**The Scottish Government
Energy Consents Unit**

**Scoping Opinion on behalf of Scottish Ministers under the
Electricity Works (Environmental Impact Assessment) (Scotland)
Regulations 2017**

**Achany Extension Wind Farm
SSE Renewables**

13th August 2025

OUR REF; WID13890

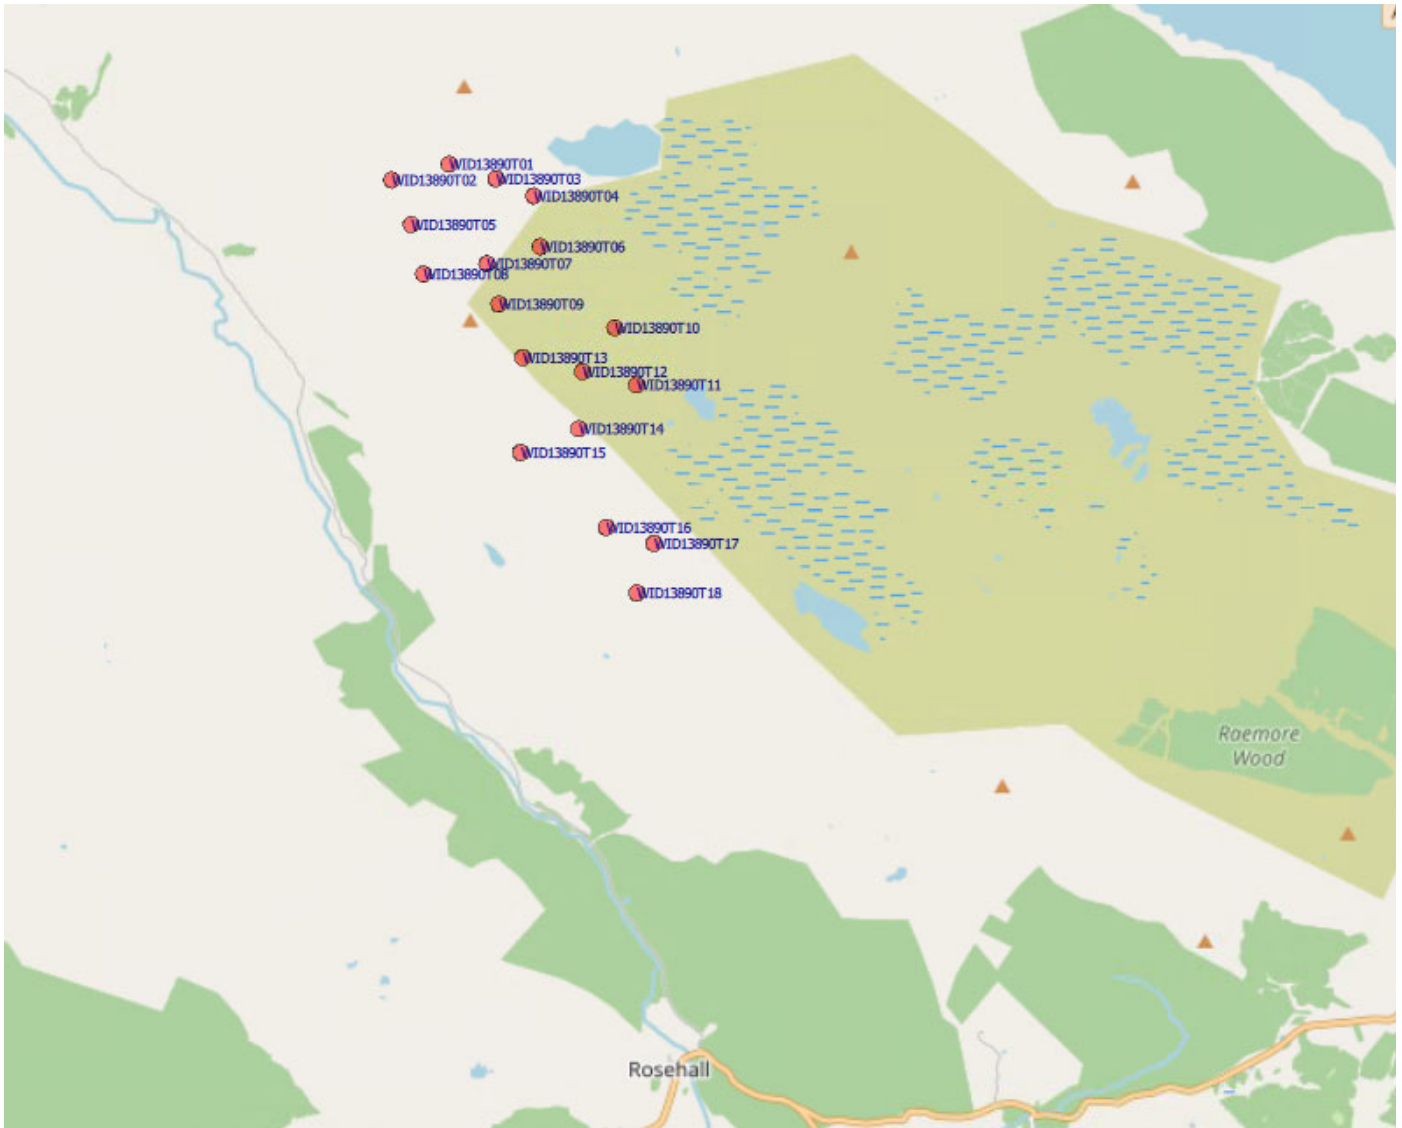
We have studied this proposal using the below co-ordinates with respect to EMC and related problems to BT point-to-point microwave radio links.

The conclusion is that this proposal should not cause interference to BT's current and presently planned radio network.

BT requires 100m minimum clearance from any structure at height to the radio link path. It should be noted that this decision is for the date of its issue as the use of the spectrum is dynamic and can change on an ongoing basis. Therefore, please reconsult us if there are any further changes during the planning process with heights and locations of any structures, and its finalisation, as we may have new links assigned by Ofcom over its duration.
